APPLICANTS: SOUTHERN CALIFORNIA EDISON COMPANY (SCE)  
SAN DIEGO GAS AND ELECTRIC COMPANY (SDG&E)

FACILITY: SAN ONOFRE NUCLEAR GENERATING STATION, UNITS 2 AND 3

SUBJECT: SUMMARY OF SAN ONOFRE MEETING ON CE-1 CORRELATION

# COMPARISON OF CE AND GEORGIA TECH SUBCHANNEL MODELS

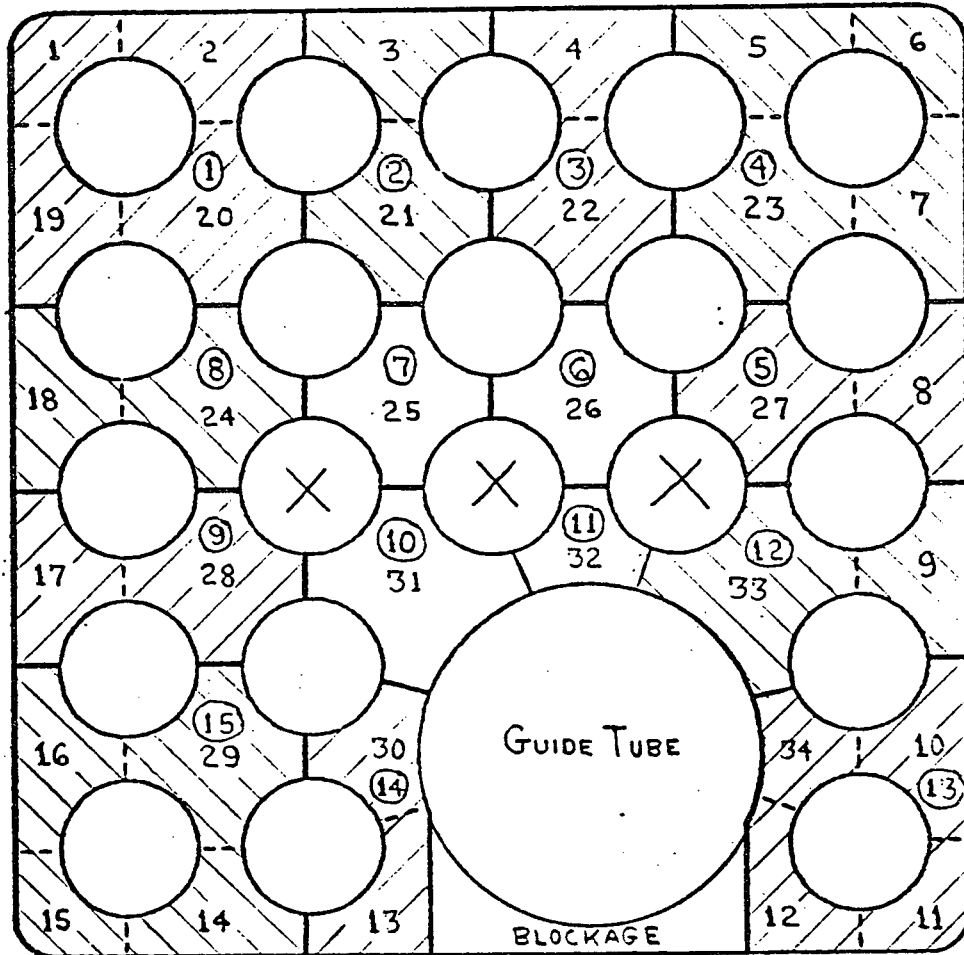
- 15 CHANNEL MODEL USED
- TWO FEW POINTS USED TO MODEL AXIAL POWER SHAPES
- 19% OF POINTS COME FROM LUMPED CHANNELS

- ALL CHANNELS MIX WITH COOLER LUMPED CHANNELS
- POWER UNDERESTIMATED BY AS MUCH AS 10%
- QUALITIES ARE TOO LOW THEREFORE CHF PREDICTIONS ARE TOO HIGH

The fact that CHF occurs on the interior rods does not justify lumping peripheral and boundary subchannels. Conversely, if the modelling simplification were justifiable then C-E could have omitted the peripheral rods in the test.
